Project No.0751  
MHI Ref: UAP-HF-08037

**Subject:** Responses to NRC's Questions for NRC's Acceptance Review of the US-APWR  
Design Certification Application

**MHI's Responses to NRC's Questions  
for NRC's Acceptance Review  
of the US-APWR Design Certification Application**

**MHI's Responses to NRC's Questions  
on Design of the Sump Strainers**

Figure-1  $^{155}\text{Gd}$  and  $^{157}\text{Gd}$  isotopic depletion

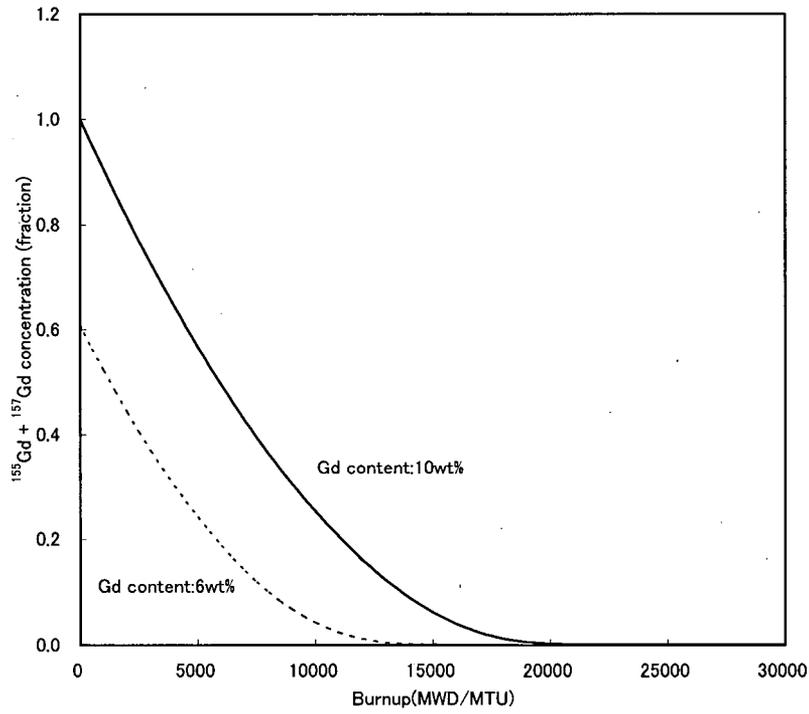
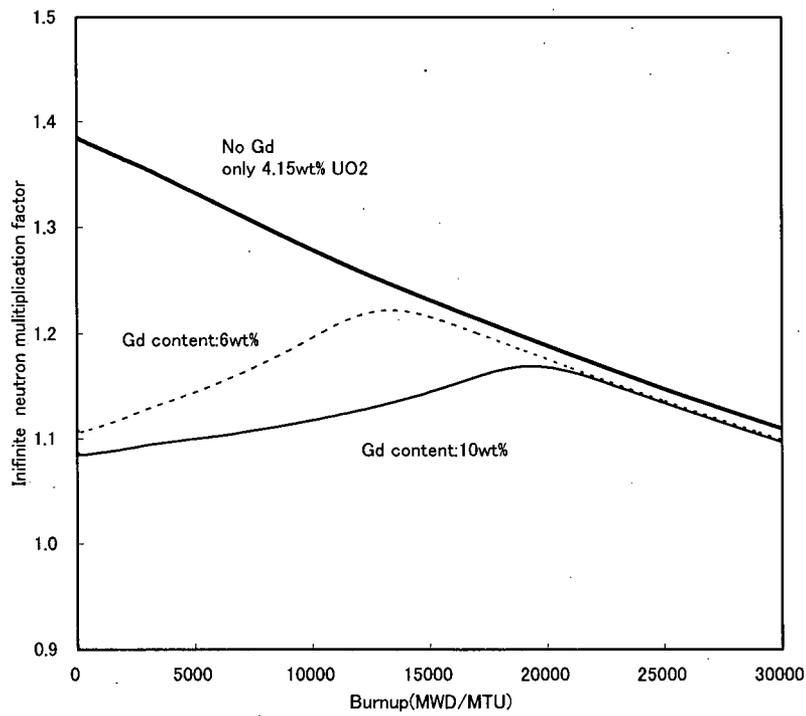
US-APWR DCD Section 4.3: The NRC requests MHI to provide a graphical or tabular depiction of Gadolinia depletion as a function of burnup.

Among Gd isotopes,  $^{155}\text{Gd}$  and  $^{157}\text{Gd}$  have the largest absorption cross sections and are therefore of primary interest. The depletion of these isotopes as a function of fuel burnup is described below for 4.15wt% fuel assemblies with 6wt% and 10wt% Gadolinia fuel rods, which belong to regions R3GC and R3GB of the US-APWR initial core shown in Figure 4.3-2 of the US-APWR DCD. The burnups of these fuel regions are shown in Table-1 for BOC, MOC and EOC.

Figure-1 shows  $^{155}\text{Gd}$  and  $^{157}\text{Gd}$  isotopic depletion, where the sum of initial number density of  $^{155}\text{Gd}$  and  $^{157}\text{Gd}$  of 10wt% Gadolinia fuel is normalized as a unit.  $^{155}\text{Gd}$  and  $^{157}\text{Gd}$  concentration decrease monotonically with increase of the burnup.

Figure-2 shows  $k_{\text{inf}}$  (infinite neutron multiplication factor) values as a function of burnup for the fuel assembly types shown in Table-1. The  $k_{\text{inf}}$  of the fuel regions containing Gadolinia increase monotonically as the Gadolinia depletes, showing a peak in  $k_{\text{inf}}$  at a burnup of approximately 15 to 20 GWD/MTU. After the peak, the  $k_{\text{inf}}$  decrease with burnup is similar to that of Uranium fuel without Gadolinia fuel rods. Comparing the burnups of Table-1 with Figure-1 and Figure-2, it can be concluded that  $^{155}\text{Gd}$  and  $^{157}\text{Gd}$  have been entirely depleted by the EOC of the initial core.
